COMMUNITY DEVELOPMENT

DEPARTMENT REPORT

SUBJECT: [H-2023-0071](#)
District at Ten Mile – CPAM, MDA, RZ, PP

LOCATION: Northwest corner of S. Ten Mile Rd. & I-84 in Section 15, T.3N., R.1W.

C. Future Land Use Map – Adopted vs. Proposed

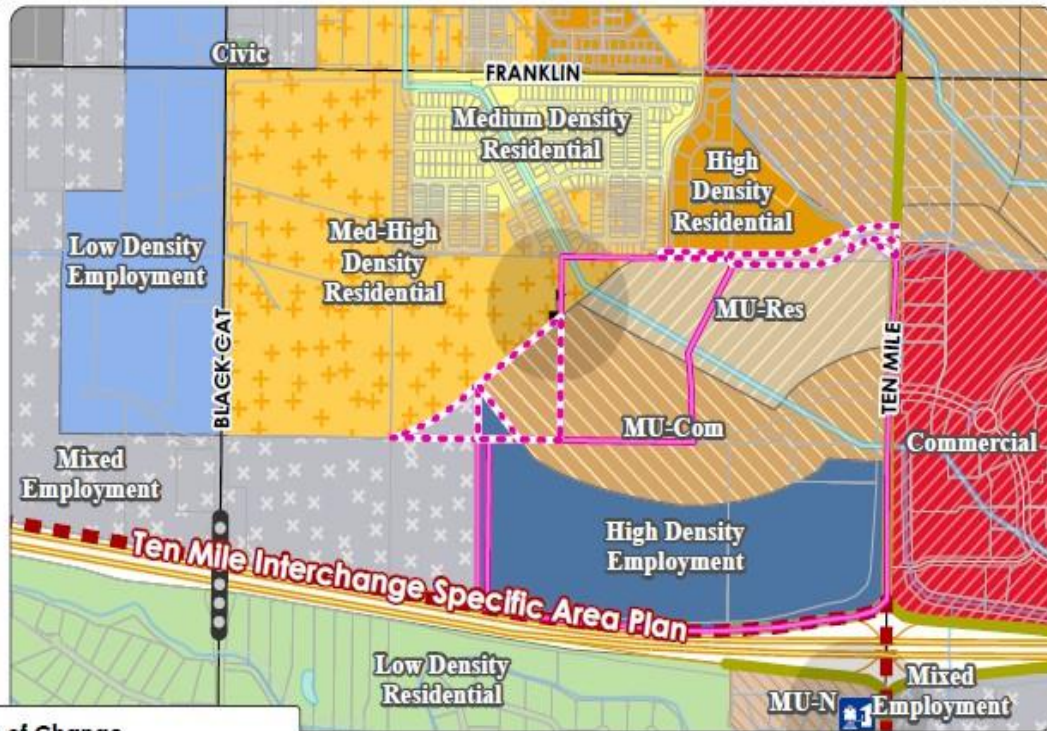
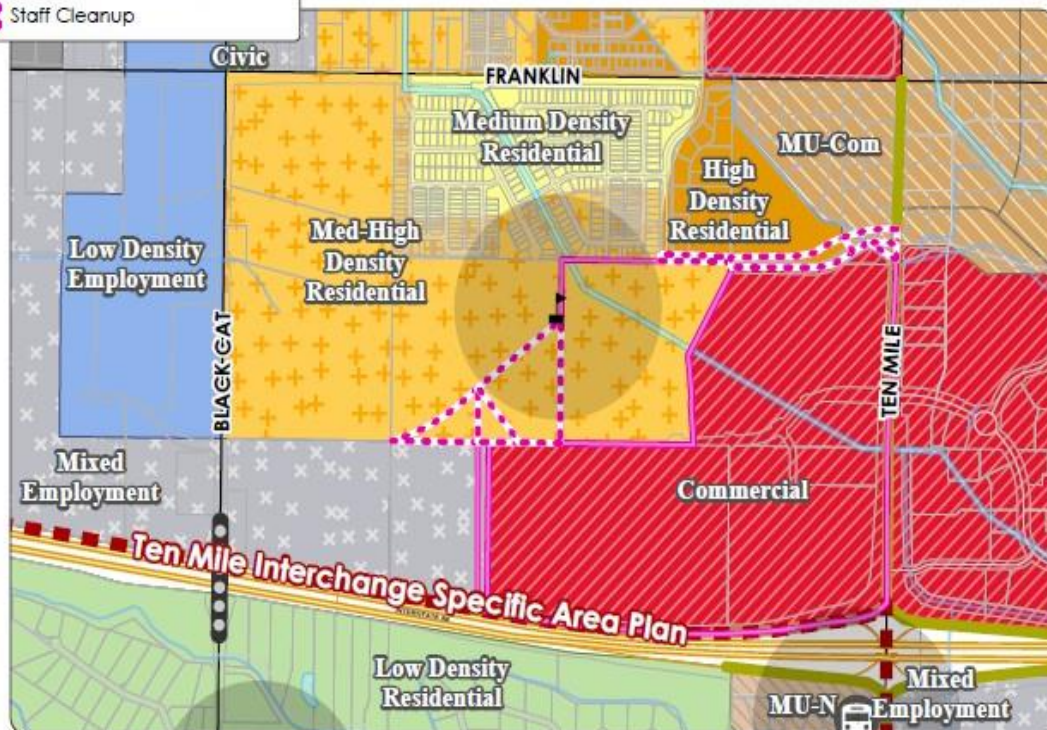
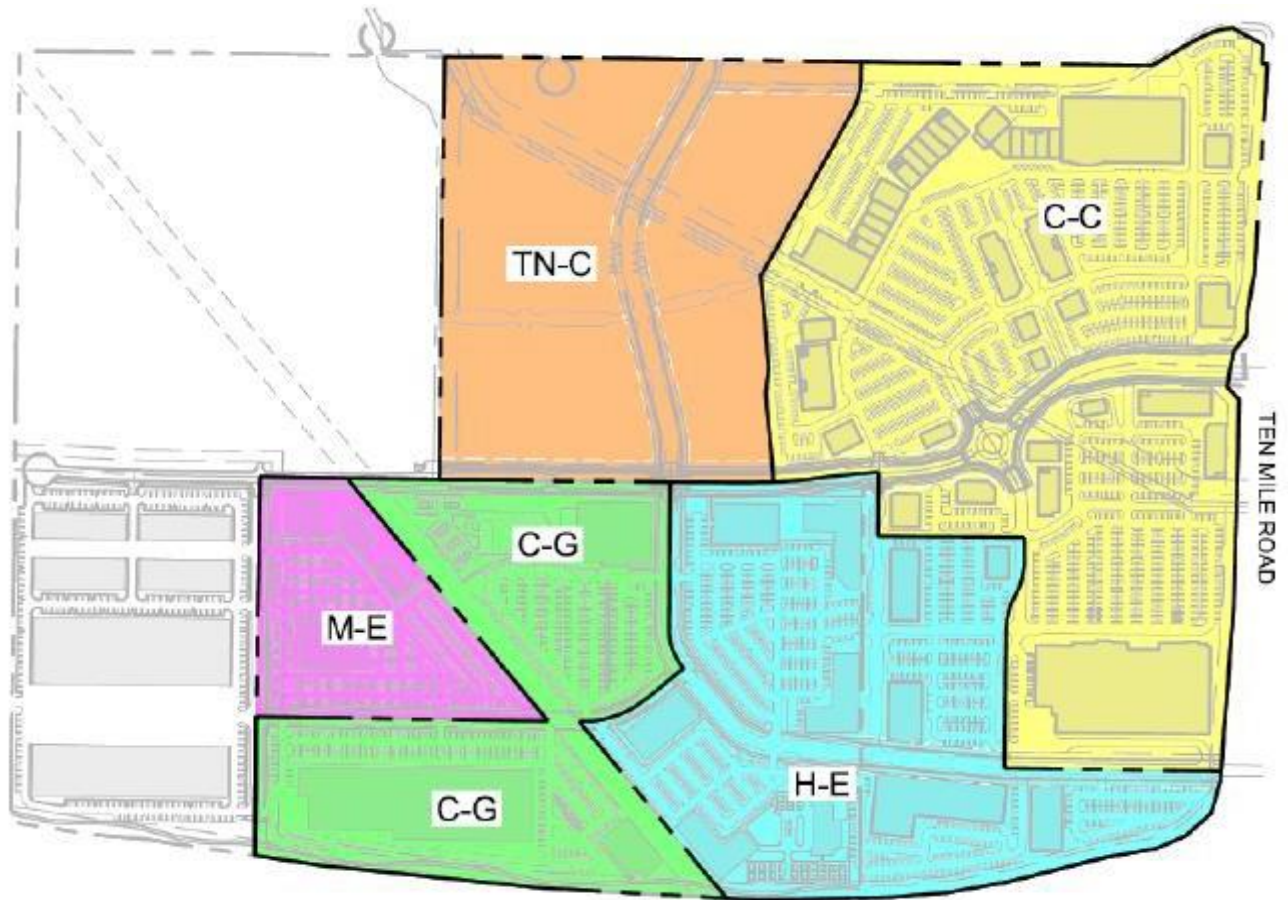
In summary, Staff is *not* in support of the proposed map amendment and associated rezone based on the conceptual development plan proposed as it doesn’t meet the *minimum* development guidelines in the TMISAP nor does it provide the mix of *integrated* uses desired in Mixed Use designated areas or the intensity and/or types of uses desired in the MU-Com and HDE designated areas.

If Council is of the opinion the proposed development plan is more appropriate for this area than that envisioned in the adopted TMISAP, Staff suggests alternate FLUM designations and zoning are approved consistent with the proposed development plan, as follows: MHDR and R-15 zoning for the property in Area 1; and Commercial and C-G zoning in Areas 2 and 3 (see second adopted vs. proposed FLUM exhibit in Section

If City Council is in favor of the proposed development plan, Staff suggests changes to the FLUM and associated zoning to coincide with the proposed plan (i.e. Area 1 – MHDR FLUM designation with R-15 zoning; Areas 2 & 3 – Commercial FLUM designation with C-G zoning) and the following development agreement provisions and conditions of approval: If Council is not in favor of the proposed development plan, Staff recommends denial of the MDA, CPAM and RZ applications and striking the following DA provisions and conditions

H. Use Area Plan

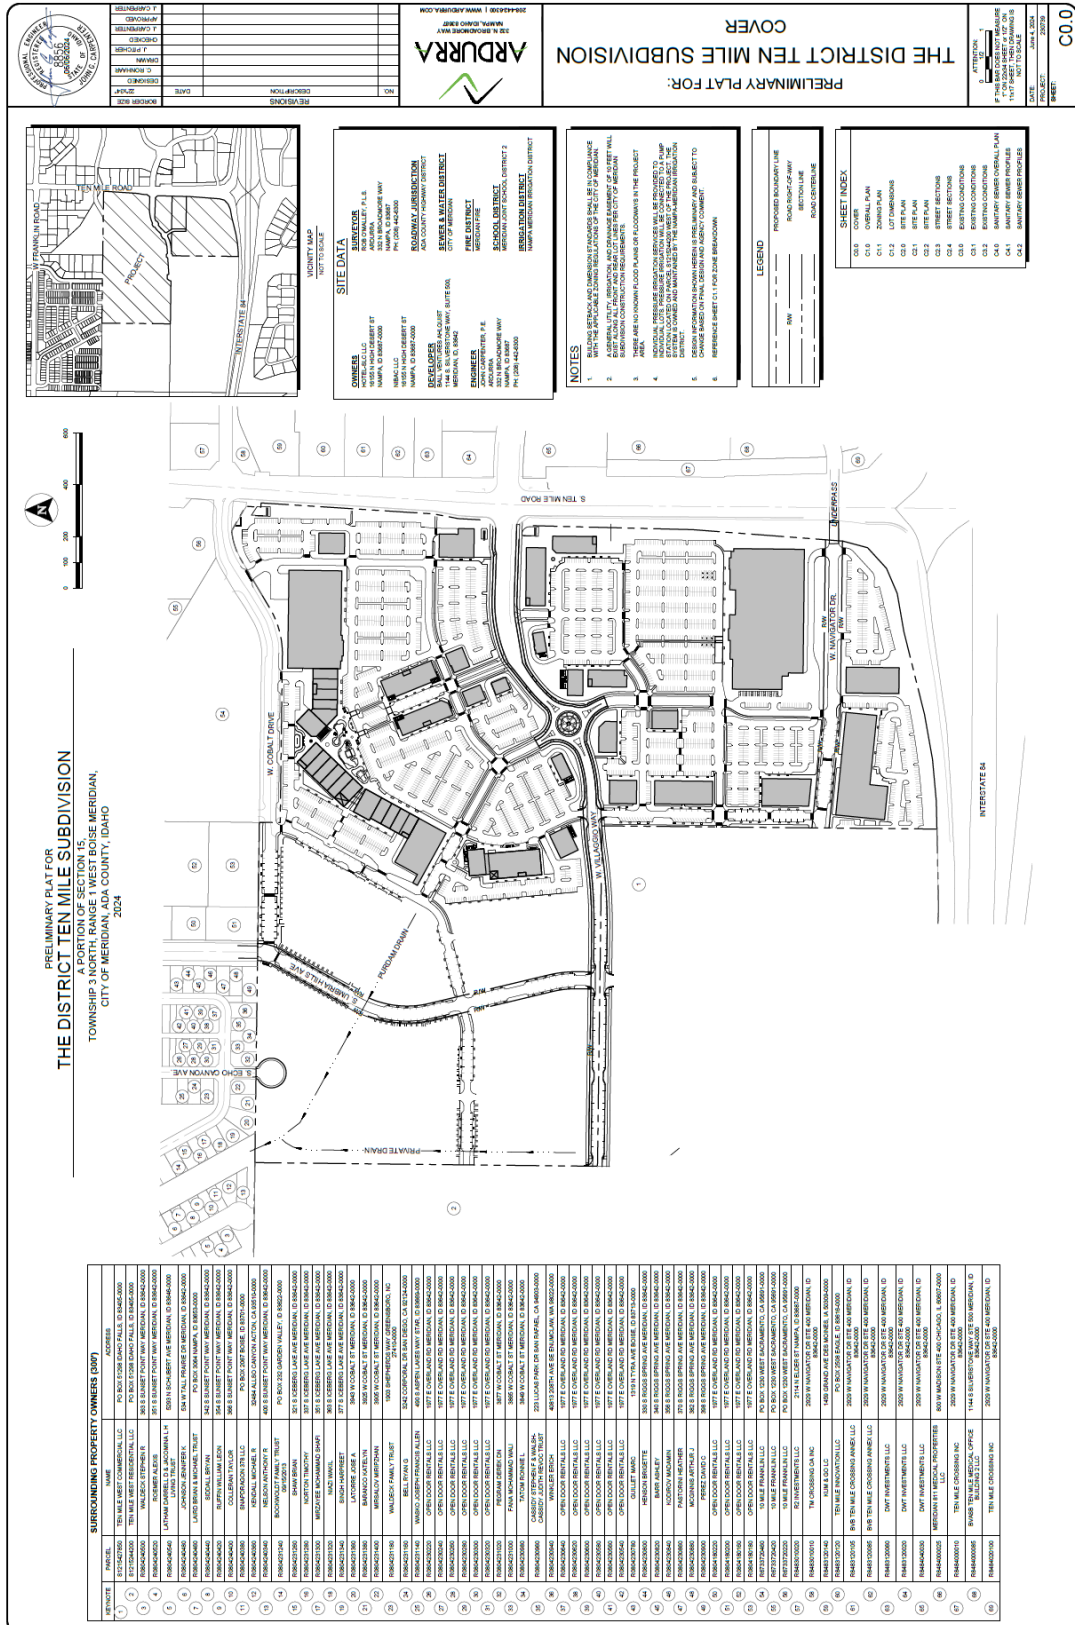
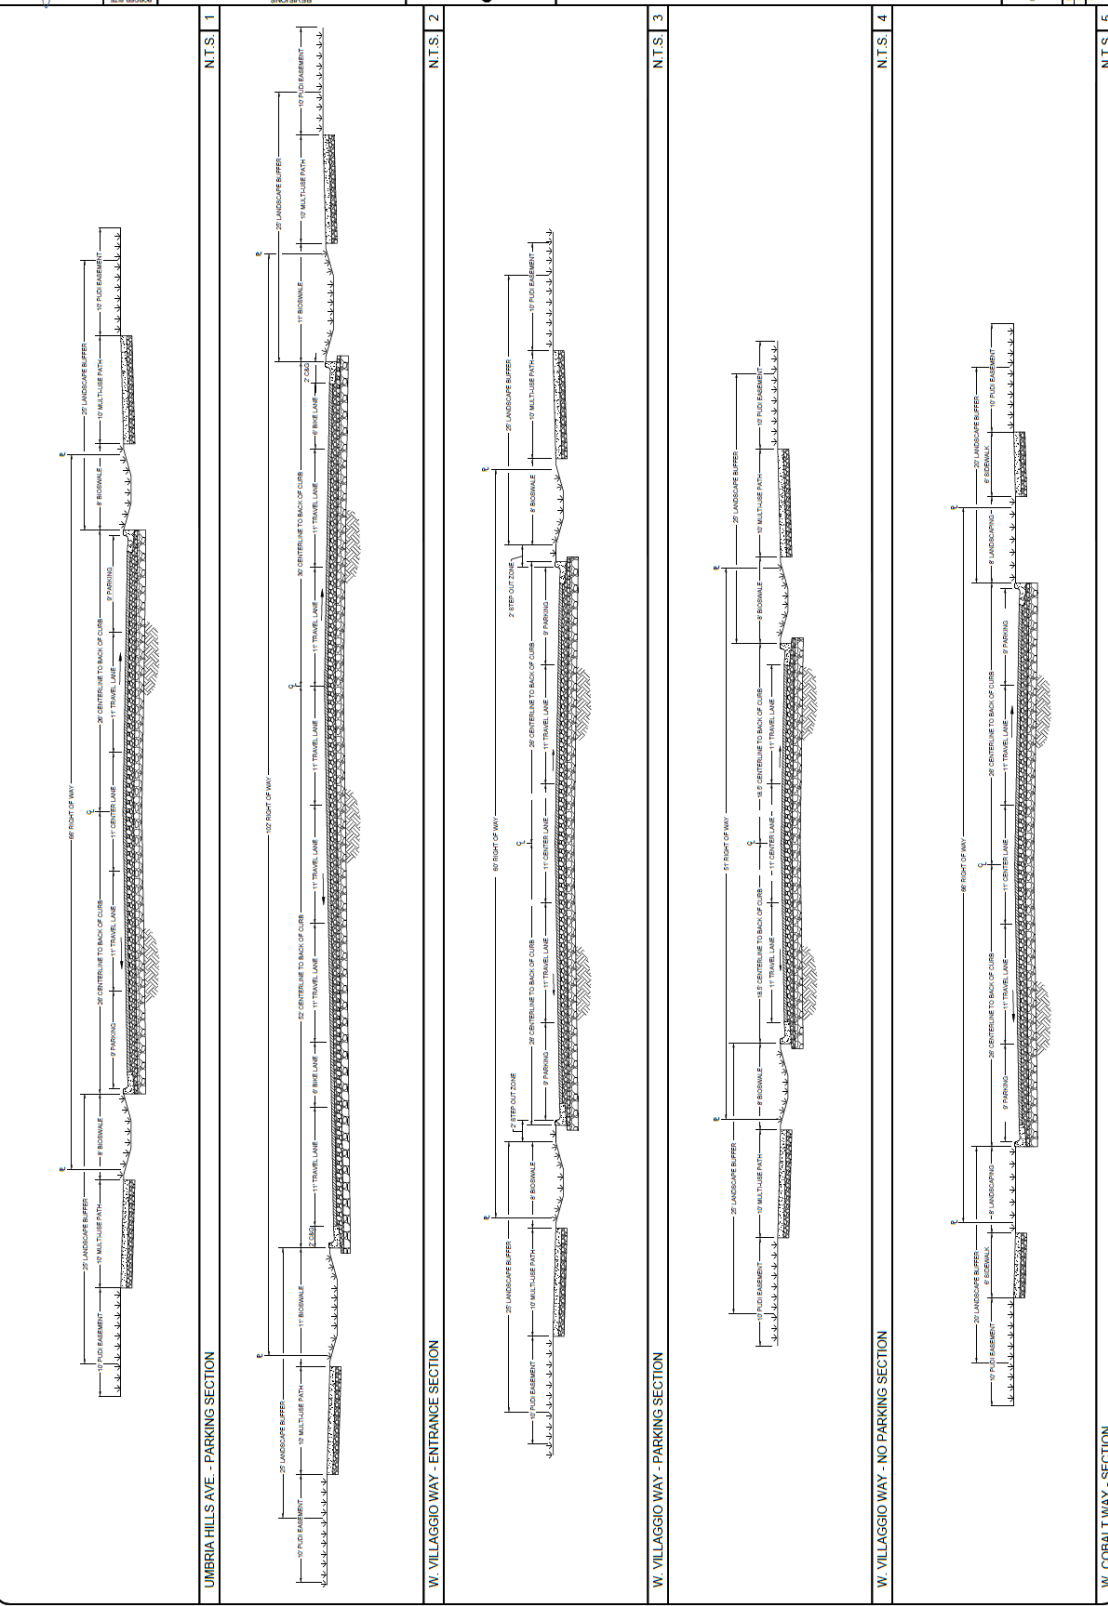
A Use Area Plan was submitted with this application and included below in Section VI.H. The Plan depicts three (3) different areas; however, the boundaries of these areas do not coincide with the proposed FLUM designation boundaries, which makes determining consistency with the FLUM designations difficult. These areas are as follows:

Only residential uses are proposed in the requested MU-Res FLUM designation and TN-C zoning district – the “mixed-use” component of the designation and TN-C district is *entirely* missing. Only one of the three major use categories are proposed (i.e. residential) – no retail, office or employment uses are proposed as required, which are essential in MU-Res designated areas. The proposed MU-Res designation and TN-C zoning is *not* consistent with the proposed development plan or the intended plan for this area as the required mix of *integrated* uses is not provided.

Although a mix of commercial uses are proposed, only one of the three major use categories is provided (i.e. commercial) – no major employment uses are proposed as required in either the MU-Com or the HDE areas and integrated residential uses are not proposed in the MU-Com area, which are essential. The proposed MU-Com and HDE designations are *not* consistent with the proposed development plan or the intended plan for this area as the required mix of uses is not provided – significant changes to the concept plan and use area plan would be needed in order to be consistent.

See above for information on MU-Com and HDE designated areas and associated analysis. **As noted above, the FAR’s in the MU-Com and HDE areas are *significantly* below the established goals in the Plan. Although commercial and employment uses are proposed from the three (3) major use categories, integration of residential uses is not proposed as desired. Office and other employment uses need to be of a much higher intensity in this area in order to be consistent with the MU-Com and especially the HDE designation and designed as compact urban centers rather than lower density suburban-style development Recreation uses are not desired in HDE designated areas.**
